# ROCKY FLATS SITE

## REGULATORY CONTACT RECORD 2015-01

**Purpose:** Reportable condition for uranium 12-month rolling average at Point of Compliance WALPOC (this Contact Record supersedes RFLMA CR 2014-10)

**POC Gaging Station WALPOC: Total Uranium Water Quality (9/12/11 - 10/22/14)**

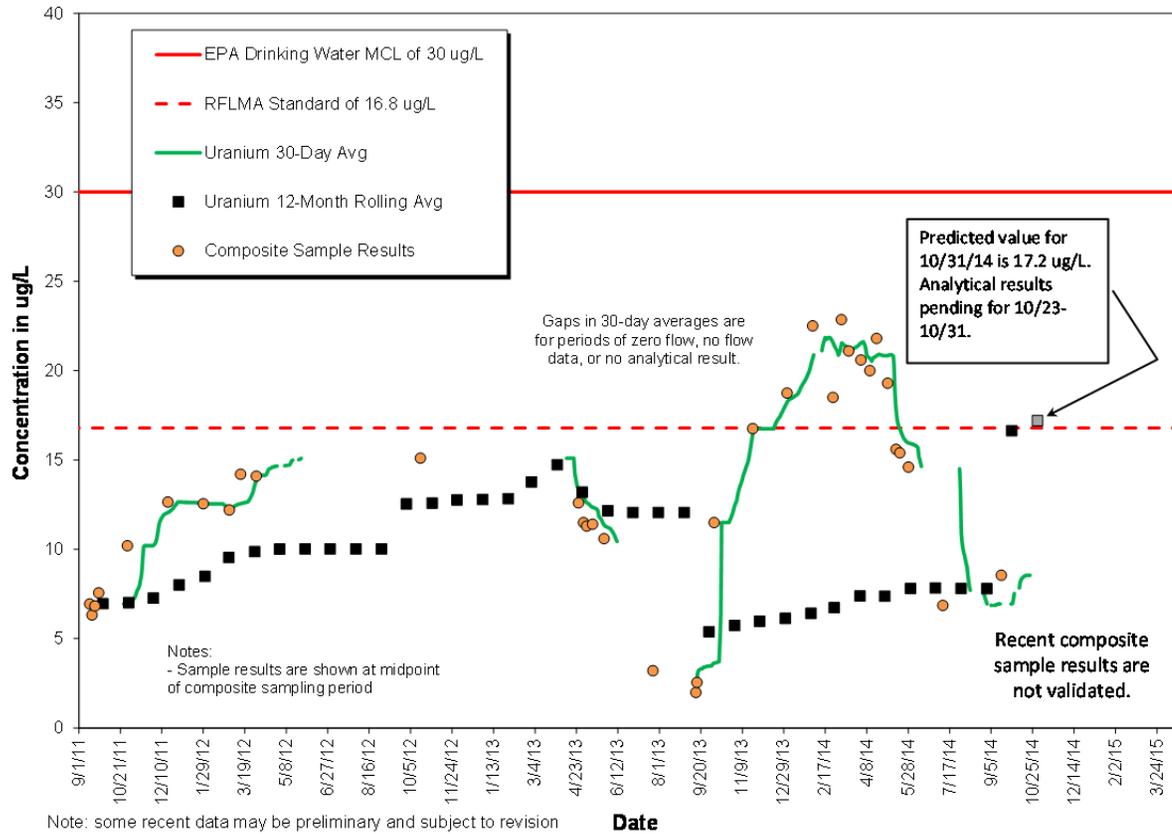
- Preliminary results from the ongoing geochemistry study, referenced in Contact Record (CR) 2014-05 ("Reportable condition for evaluation purposes for uranium at Point of Compliance WALPOC," dated April 8, 2014), indicate that the increases in the 30-day rolling average uranium concentrations at WALPOC were caused by the September 2013 100-plus-year flood event, and will eventually return to below the 16.8 µg/L concentration. This projected decrease in uranium concentrations at WALPOC did occur in May 2014, when the 30-day average and composite samples concentrations dropped below 16.8 µg/L (see Attachment 1).

Figure 1. Location of Excavation for Storage Shed PV Upgrades Project

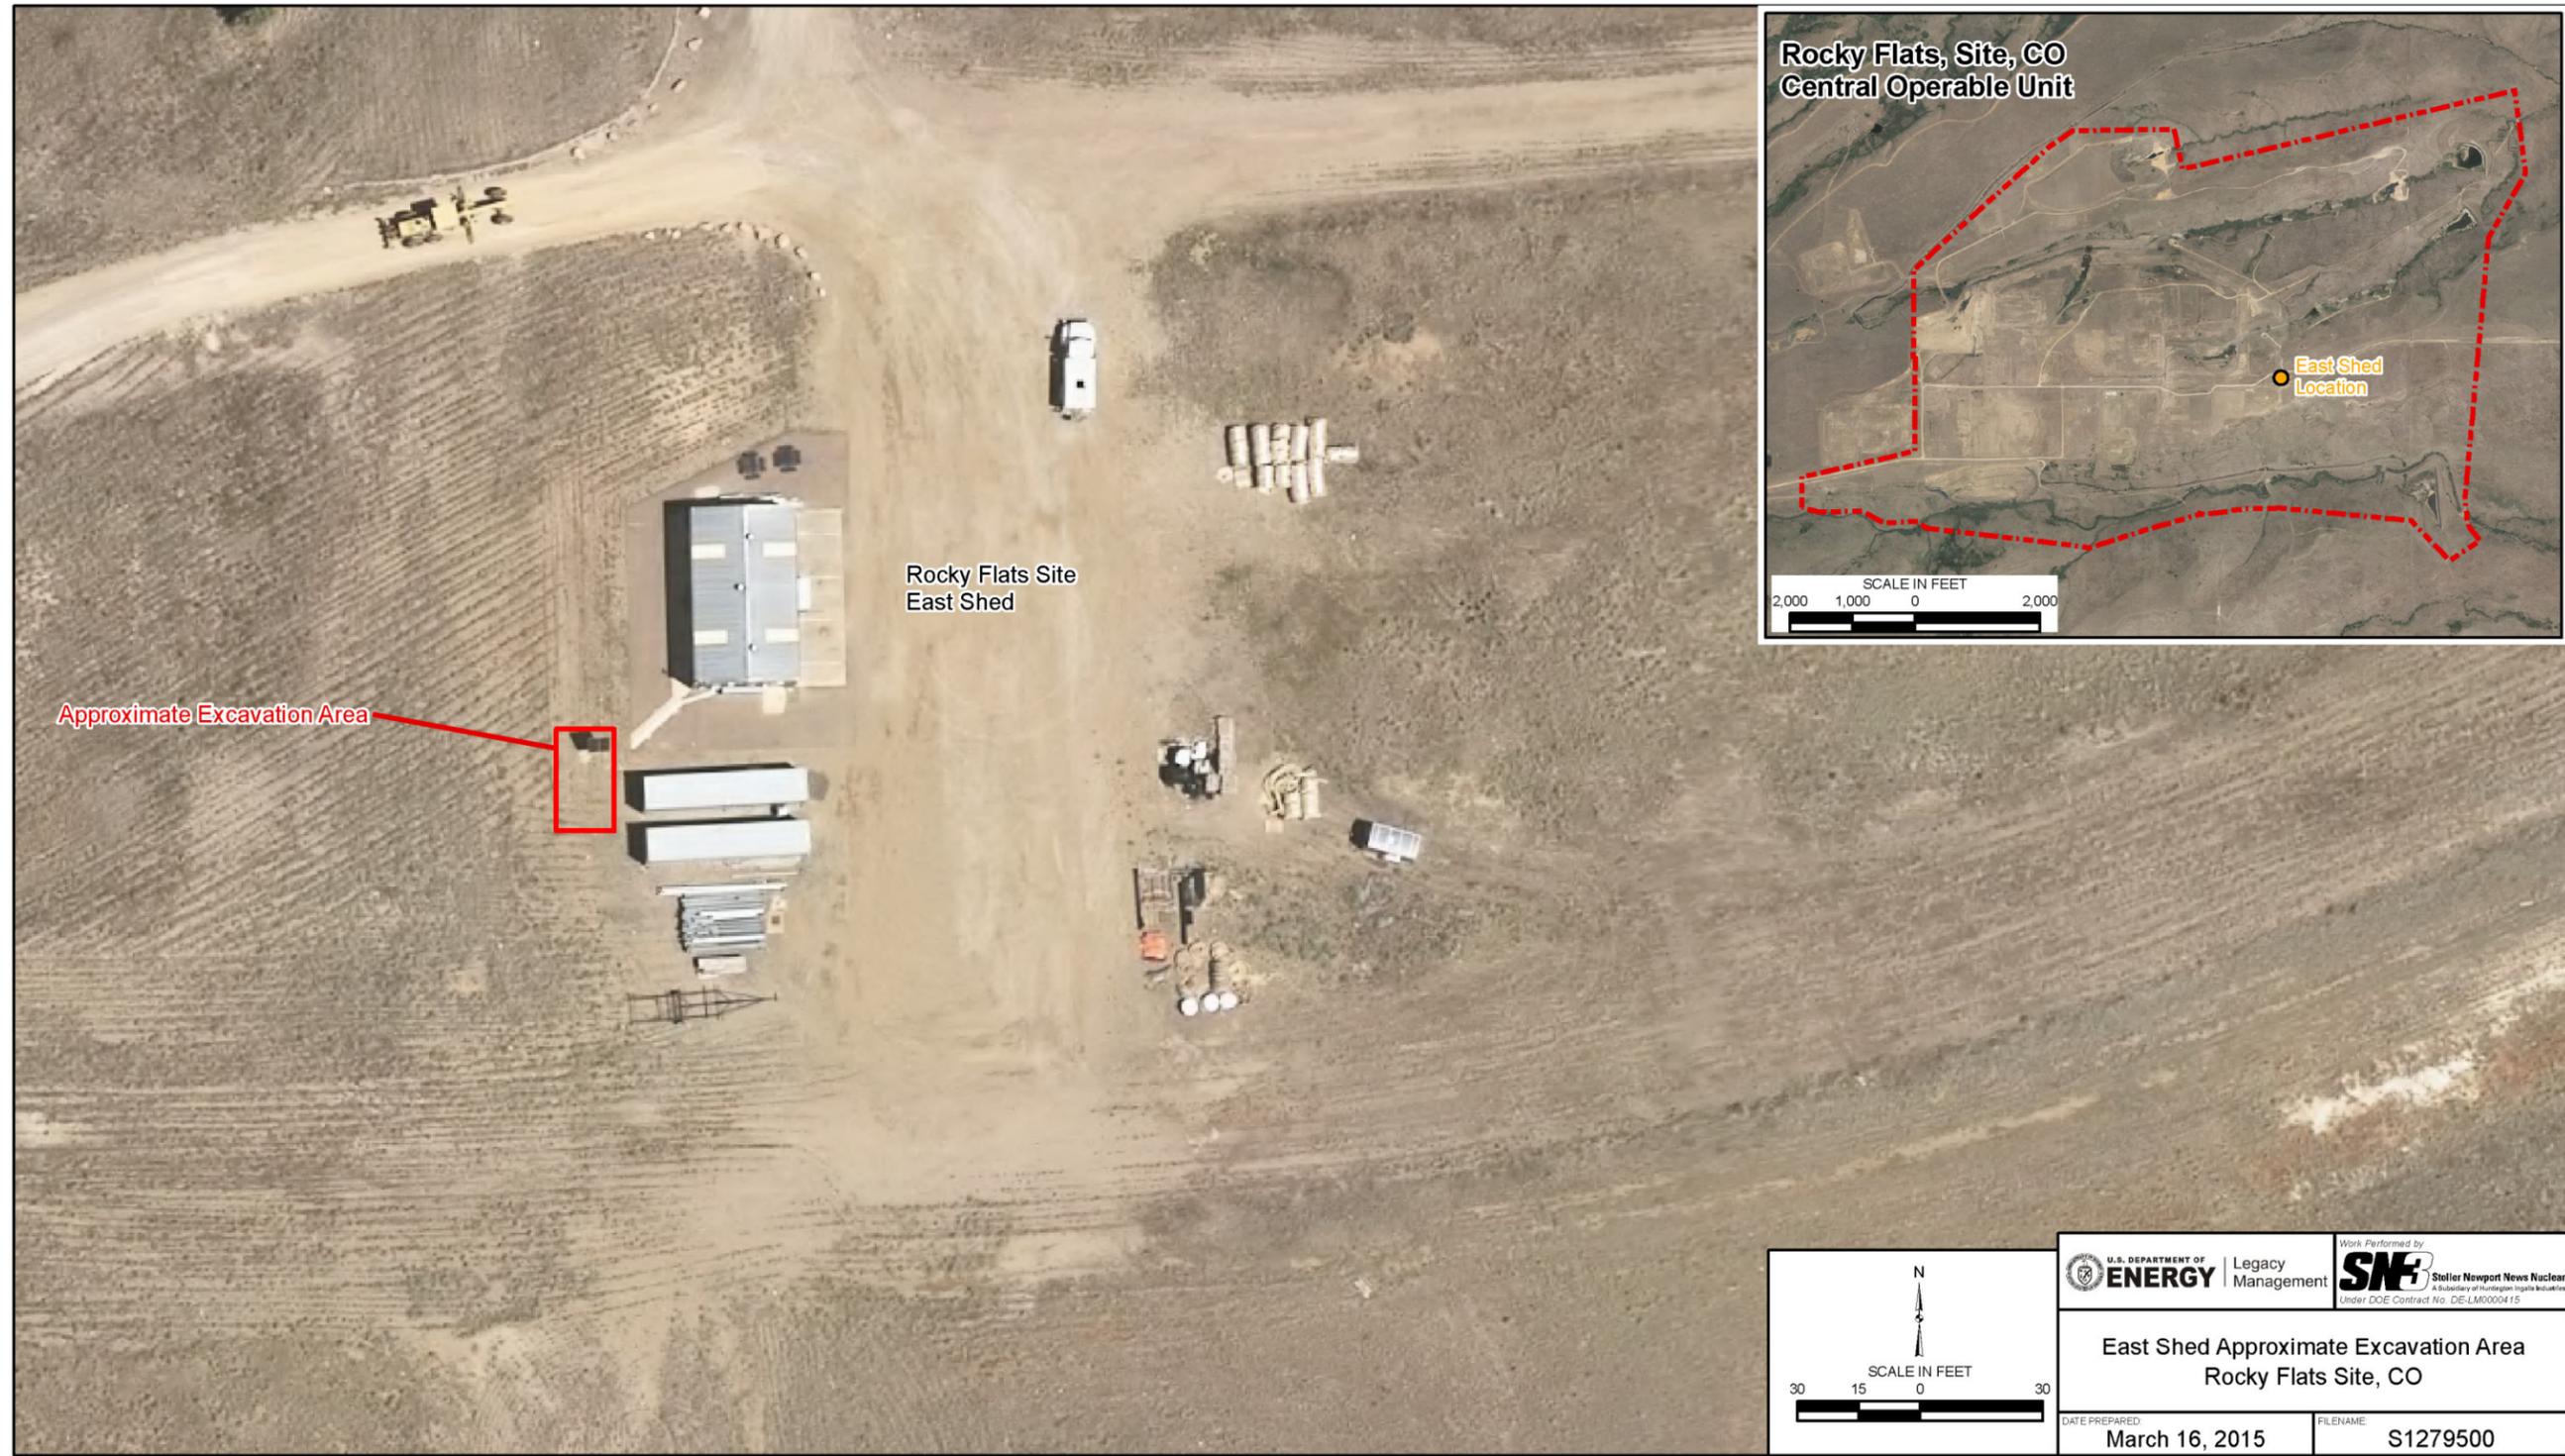
The soil disturbance that occurs during the excavation of the holes for the support of the new PV panels is subject to the requirements of certain *Rocky Flats Legacy Management Agreement* (RFLMA) institutional controls (ICs), as discussed below. An approved SDRP is required and the RFLMA parties agree that Figure 1 provides sufficient information for the SDRP for the proposed work.

Holes, 12-inches in diameter and approximately 3 feet deep, will be drilled and filled with concrete. The additional PV panels will be supported by the new concrete footings. Figure 1 in Contact Record 2015-02 shows the approximate location of the new supports.

**Resolution:** CDPHE has review information regarding the proposed soil disturbance and excavation and, after consulting with EPA, has approved the proposed activity and the proposed grading plan. CDPHE has determined that the proposed activity will not compromise or impair the function of the remedy or result in an unacceptable release or exposure to residual subsurface contamination. CDPHE has also determined that the proposed project meets the rationale and objectives of IC 2.

Figure 1

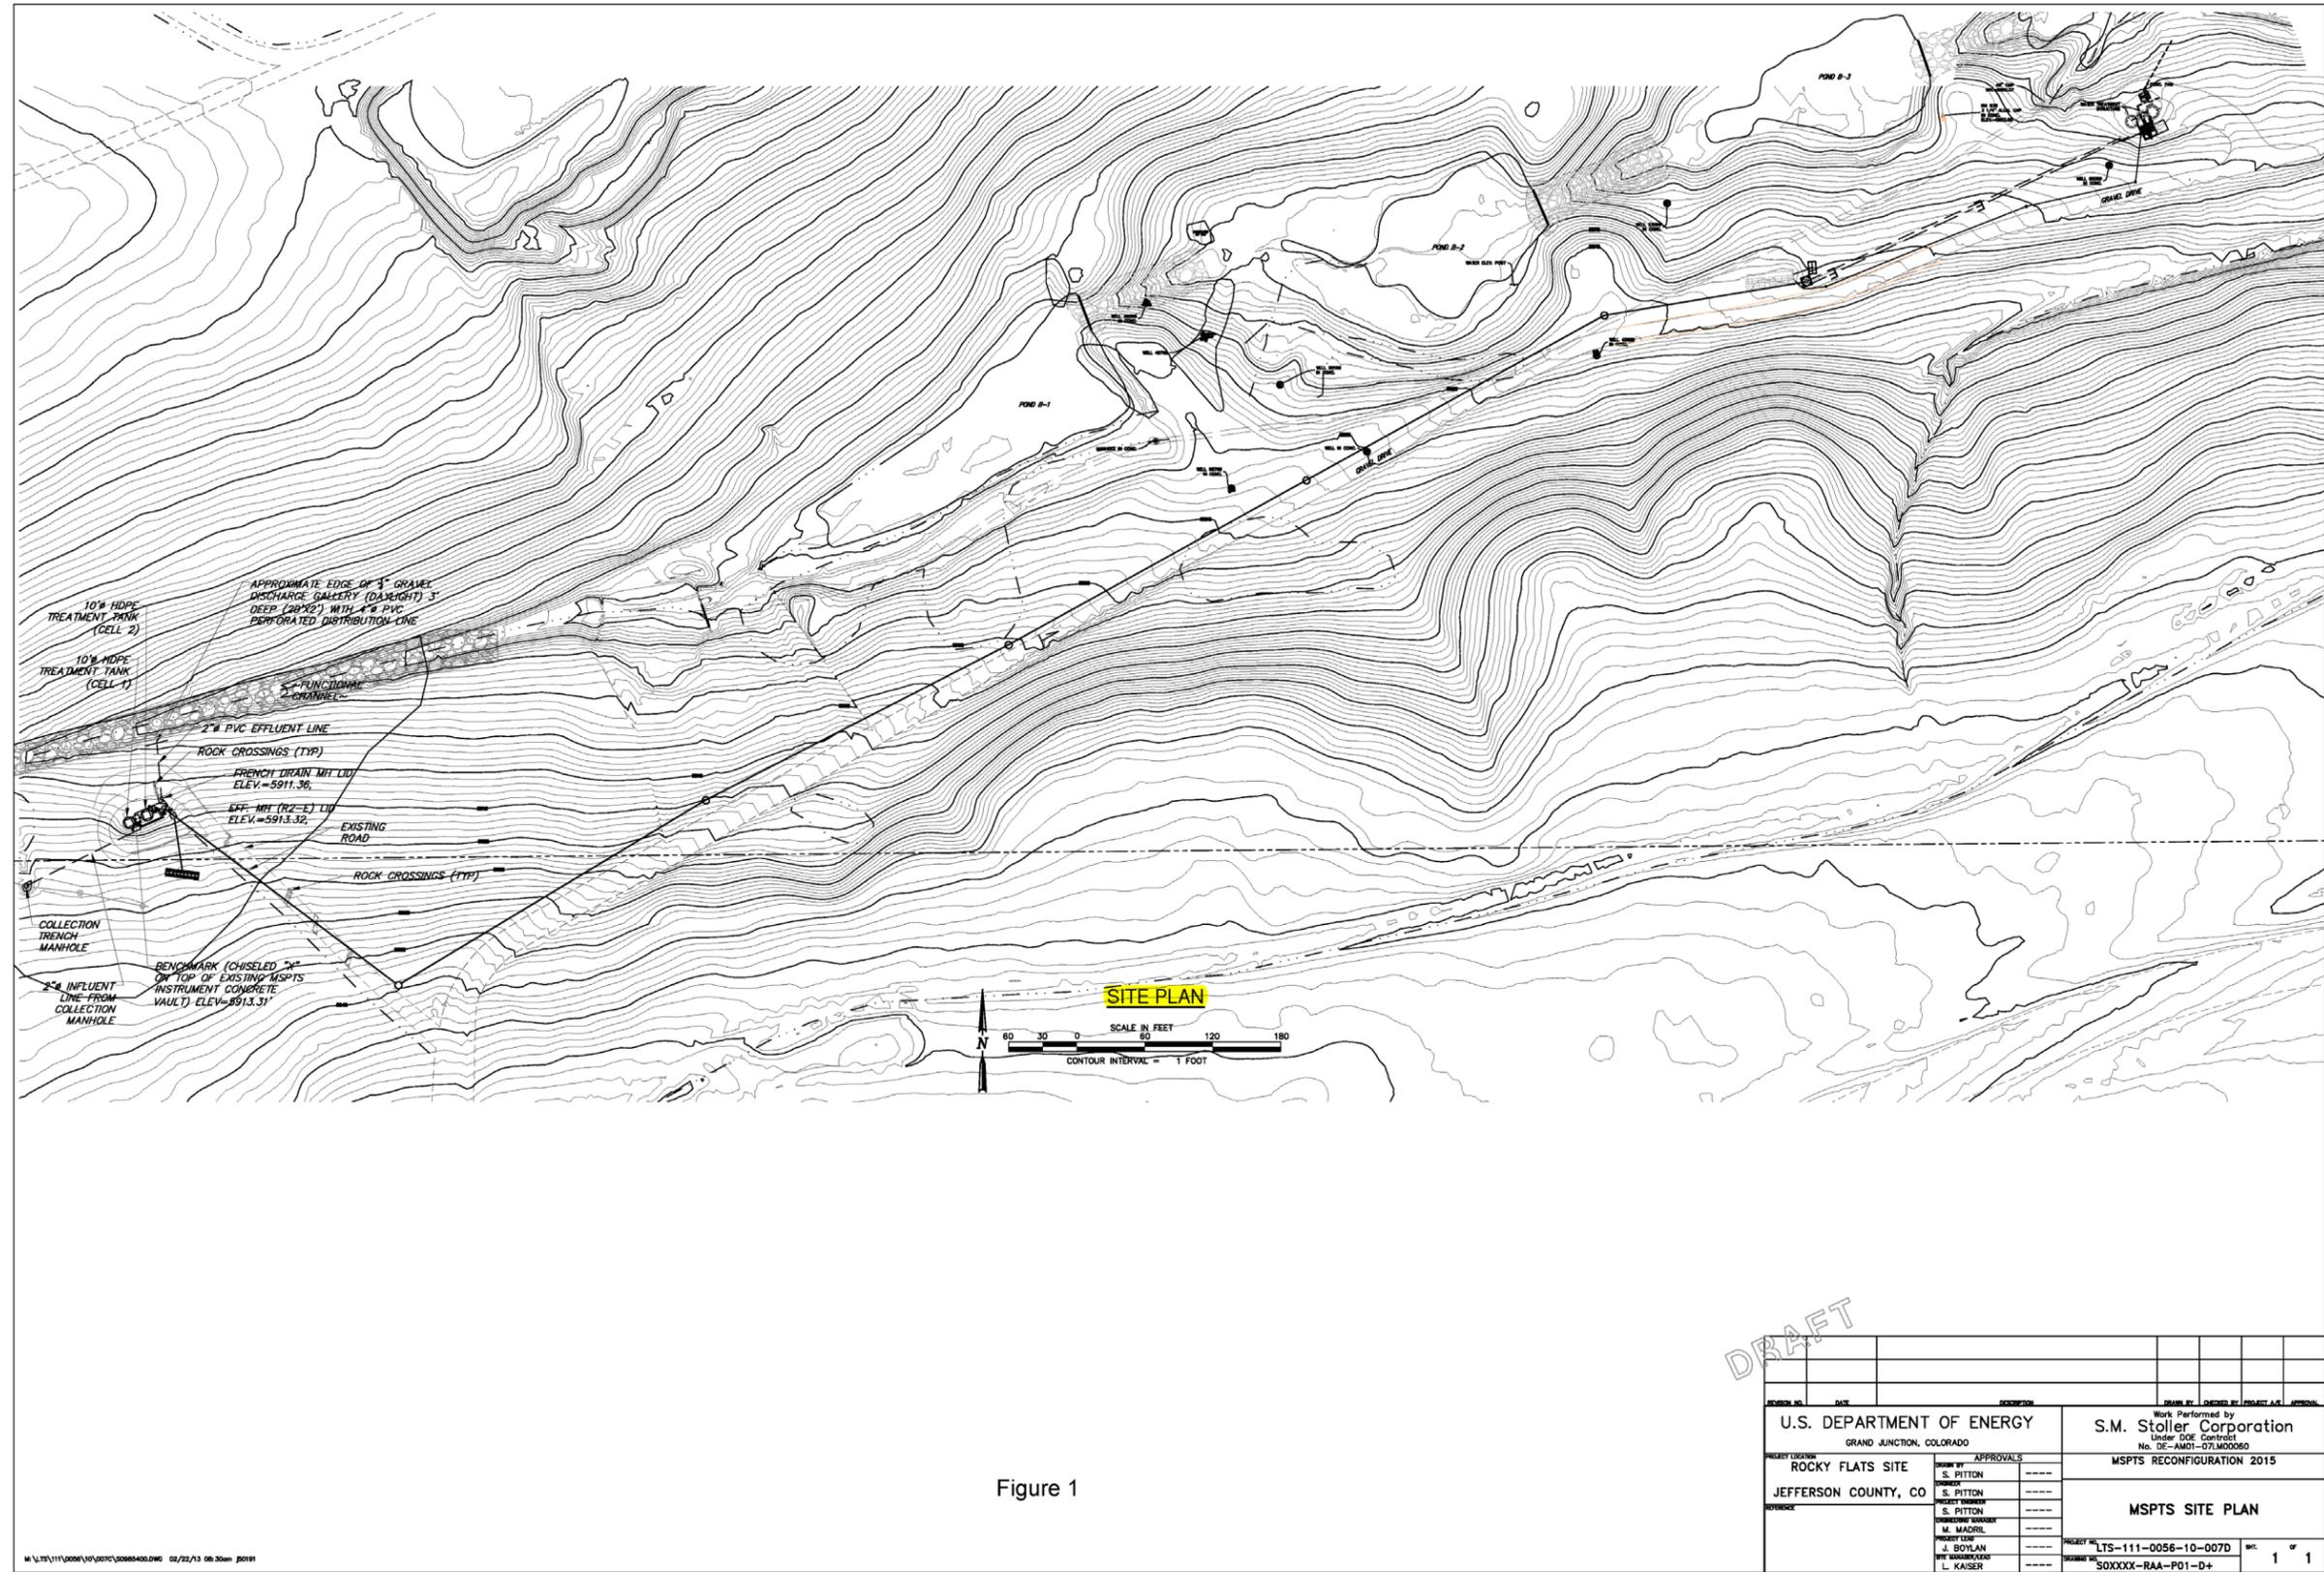
A conceptual approach has been developed and discussed among the RFLMA parties. This approach includes routing the MSPTS influent to the ETPTS air stripper; see Figure 1. The existing MSPTS tanks will initially be maintained and modified for optional water storage. The existing MSPTS effluent manhole will be replaced with a lift station and pump; water collected by the MSPTS will be pumped from this lift station to the ETPTS influent manhole. The combined MSPTS and ETPTS influents would then flow to the ETPTS influent tank and be pumped to the ETPTS air stripper in batches, just as is currently done with ETPTS influent alone. Additional solar power, piping, valves, instrumentation, and other necessary components would be installed to support this approach. Minor modifications to RFLMA Attachment 2 to reflect changes in MSPTS effluent and performance sampling locations have also been identified.

**Resolution:** It was agreed that DOE will prepare engineering designs for treating the MSPTS influent using the ETPTS air stripper. The RFLMA parties will consult in a timely manner on proceeding with the MSPTS reconfiguration to allow further planning and implementation as part of the MSPTS ZVI media removal project. Approval of the reconfiguration and of any required Soil Disturbance Review Plan for the work will be documented in a subsequent contact record.

Figure 3. Planned Action Locations

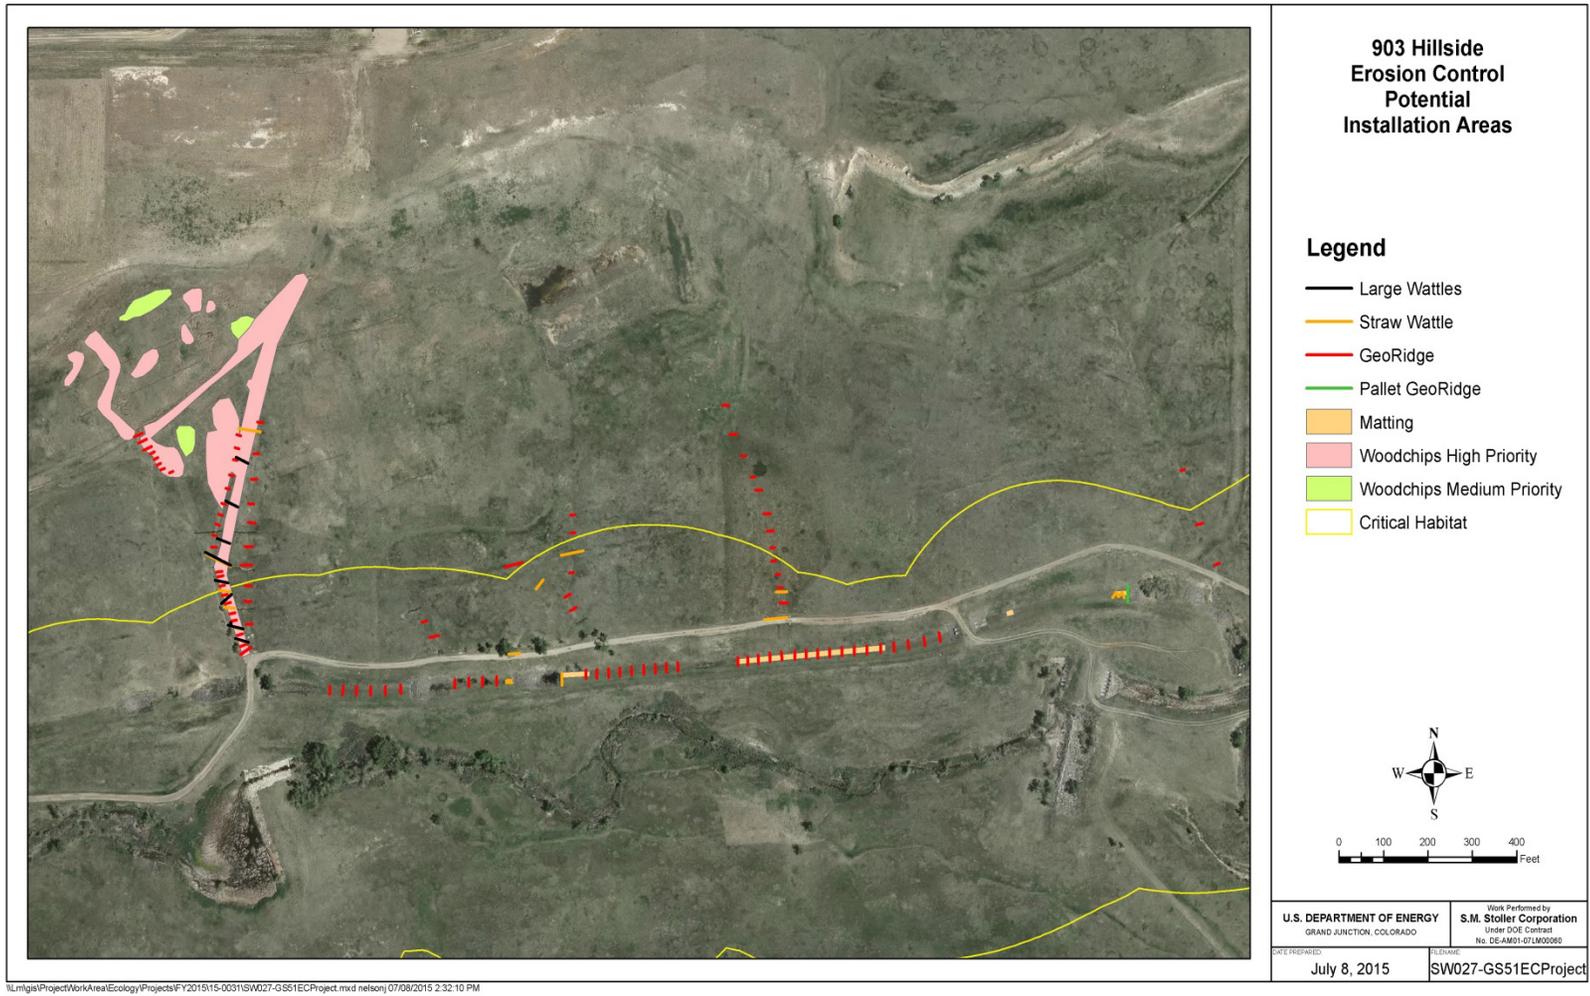
- Additional erosion control methods will be installed in the SW027 drainage, predominantly on the hillside above GS51. These measures will include matting, wattles, GeoRidge berms, and organic mulch. Several areas in the SID will also receive erosion matting; other longer-term actions for the SID are dependent on recommendations from the geotechnical engineer. Figure 3 shows the planned locations for these measures; final locations will be documented after installation. This work is scheduled to be completed by August 2015.

- On June 29, 2015, geotechnical engineers, CDPHE, and Rocky Flats personnel walked down the SID to evaluate potential use of water and sediment management devices or structures. The geotechnical engineers will provide recommendations for water and sediment management in the SID. These recommendations will be implemented in the longer term as appropriate.
